PR/0218/23

Record of Executive Business and Chief Executive's Order

Reg. Reference:	SD22A/0263	Application Date:	02-Jun-2022
Submission Type:	Additional Information	Registration Date:	26-Jan-2023
Correspondence Name and Address:		James Bryan 1307, Kill West, Kill, Kildare	
Proposed Development:		Sub-division of existing site to allow for the construction of a new 2 storey, 3 bedroom detached dwelling with a pedestrian access gate in the side boundary wall, all to the side of the existing dwelling and all associated site works.	
Location:		79, Moy Glas Chase,	Lucan, Dublin
Applicant Name:		Ger and Gillian Fox	
Application Type:		Permission	
(EW)

• Sub-division of existing site to allow for the construction of a new 2 storey, 3 bedroom detached dwelling with a pedestrian access gate in the side boundary wall, all to the side of the existing dwelling and all associated site works.

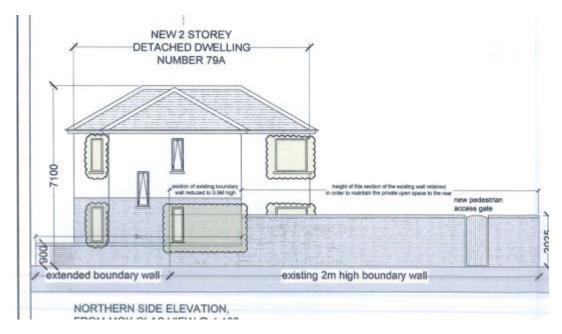
1. Having regard to the existing north-facing outer boundary wall, the Planning Authority deemed that the extended proposed wall for a further 3.6m at 2m in height would create a tunnel effect into the estate from the west and hinder maximum visibility and surveillance. Therefore, the north-facing outer boundary wall is considered to match the front (east-facing) wall and is requested to be reduced to 0.9m, which complies with the requirements of the Roads Department and the South Dublin County Council Development Plan 2022-2028.

(i) The applicant is requested to submit an elevational/sectional drawing with a revised north-facing outer boundary wall and a front (east-facing) wall with a reduced height to 0.9m.(ii) The applicant is requested to submit elevational/sectional drawings and plans that detail additional windows along the northern side elevation of the proposed dwelling.

(i)The applicant has submitted an elevational/sectional drawing with a revised north-facing outer boundary wall and a front (east-facing) wall with a reduced height of 0.9m. The applicant has noted in their cover letter that to maintain the private open space to the rear of the dwelling, the applicant has kept the height of the remainder of the north-facing wall that screens the rear garden area to 0.9m in height. This is considered acceptable to the Planning Authority.

(ii) The applicant has submitted elevational/sectional drawings and plans that detail additional windows along the northern side elevation of the proposed dwelling; these now include two first floor (3 in total) and three ground floor (4 in total) The applicant has now demonstrated that the proposal is in accordance with the South Dublin County Council Development Plan requirements.
